# SUPPLEMENTAL ENVIRONMENTAL ASSESSMENT

## CONSTRUCTION OF AN ARMED FORCES RESERVE CENTER COMPLEX AND IMPLEMENTATION OF BRAC 05 REALIGNMENT ACTIONS AT U.S. ARMY GARRISON FORT DEVENS, MASSACHUSETTS

**July 2008**

Figure 4-4. Water Resources in the Vicinity of the Fort Devens 3700 Area

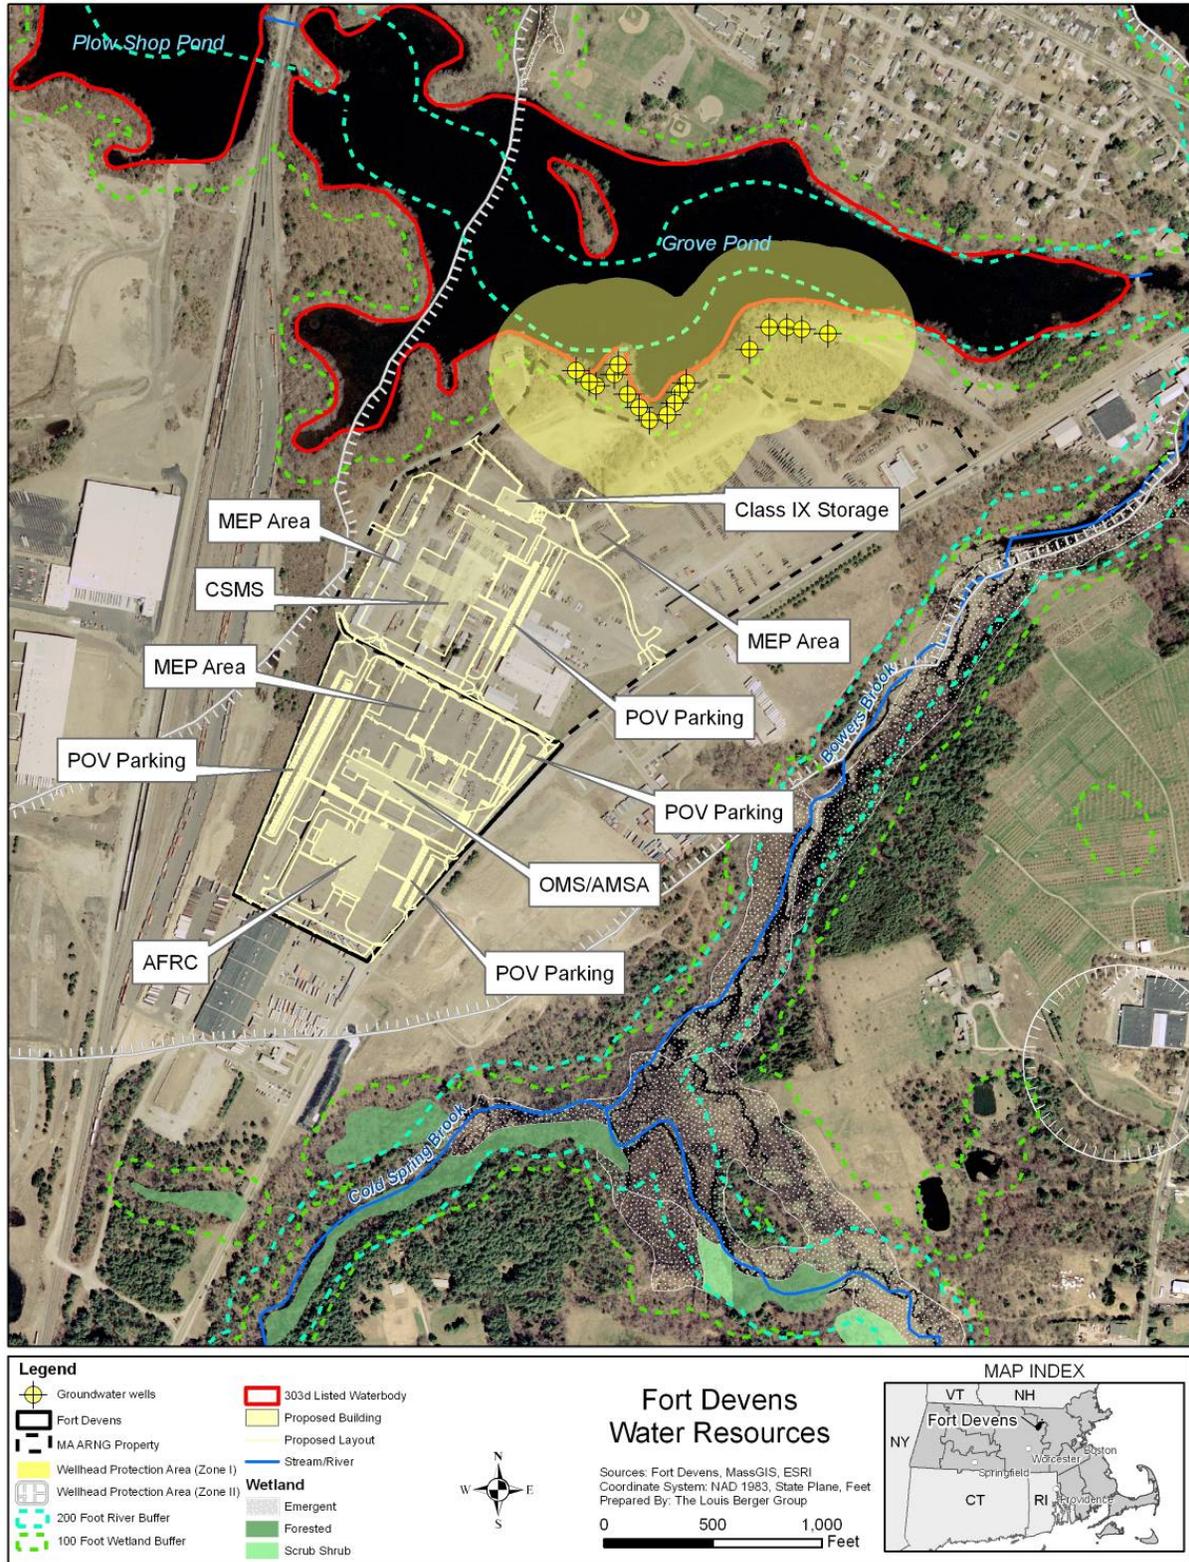
Upon learning that the MassGIS data (250 foot Zone I wellhead protection buffer for tubular wells) used for determining the layout of the MAARNG facilities as depicted in Figure 4-4 in the Supplemental EA was outdated (the wells have been replaced with gravel packed wells that require a 400 foot buffer), the U.S. Army obtained from MassDevelopment and the Town of Ayer the current wellhead locations and reconfigured the design layout of the MEP area on the MAARNG property to avoid the Zone I wellhead protection area. Figure 4-4, has been updated in the Supplemental EA to reflect the latest design layout, wellhead locations, and 400 foot protection

The project site has been reconfigured to avoid all Zone I wellhead protection buffer zones. The Zone I buffers around the Grove Pond wells depicted in *Figure 4-4 Water Resources in the Vicinity of the Fort Devens 3700 Area* in both the original and Supplemental EAs were obtained from MassGIS, the state GIS data clearing house, and depict a 250 foot buffer which is appropriate for tubular wells. This is the buffer that the U.S. Army used in designing the layout of facilities for the MAARNG property in order to avoid of the Zone I wellhead protection area. As noted in the MADEP's comments as well as at the April 23, 2008 meeting between the U.S. Army and interested stakeholders, including the Town of Ayer, MADEP and others, the U.S. Army recognizes that the MassGIS data used for determining the layout of the MAARNG facilities is outdated. Accordingly, the latest well locations were obtained from the Town of Ayer and MassDevelopment. Based on the latest locations and a 400 foot buffer (appropriate for the gravel packed wells that replaced the tubular wells), the U.S. Army reconfigured the design layout of the MEP area on the MAARNG property to avoid the Zone I wellhead protection area. Figure 4-4 in the Supplemental EA has been updated with the latest well locations and buffers. In addition, Figures 2-2 and 4-7 have also been updated to depict the latest design layout.

**Response to Comment:** The Zone I buffers around the Grove Pond wells depicted in *Figure 4-4 Water Resources in the Vicinity of the Fort Devens 3700 Area* in both the original and Supplemental EAs were obtained from MassGIS, the state GIS data clearing house, and depict a 250 foot buffer which is appropriate for tubular wells. This is the buffer that the U.S. Army used in designing the layout of facilities for the MAARNG property to avoid the Zone I wellhead protection area. As noted in the MADEP's comments as well as at the April 23, 2008 meeting between the U.S. Army and interested stakeholders, including MADEP, the Town of Ayer and others, the U.S. Army recognizes that the MassGIS data used for determining the layout of the MAARNG facilities as depicted in Figure 4-4 is outdated. Accordingly, the latest well locations were obtained from MassDevelopment and the Town of Ayer. Based on the latest locations and a 400 foot buffer, the U.S. Army reconfigured the design layout of the MEP area on the MAARNG property to avoid the Zone I wellhead protection area, and Figure 4-4 has been updated in the Supplemental EA. In addition, Figures 2-2 and 4-7 have also been updated to depict the latest design layout.

**Response to Comment:** The layout of facilities on the MAARNG property has been redesigned to avoid the 400 foot Zone I wellhead protection area and Figure 4-4 in the Supplemental EA has been updated to reflect this change. The MAARNG and the Town of Ayer already have an MOU governing the activities that can and cannot take place within the Zone I wellhead protection areas and the MAARNG will continue to abide by that MOU.
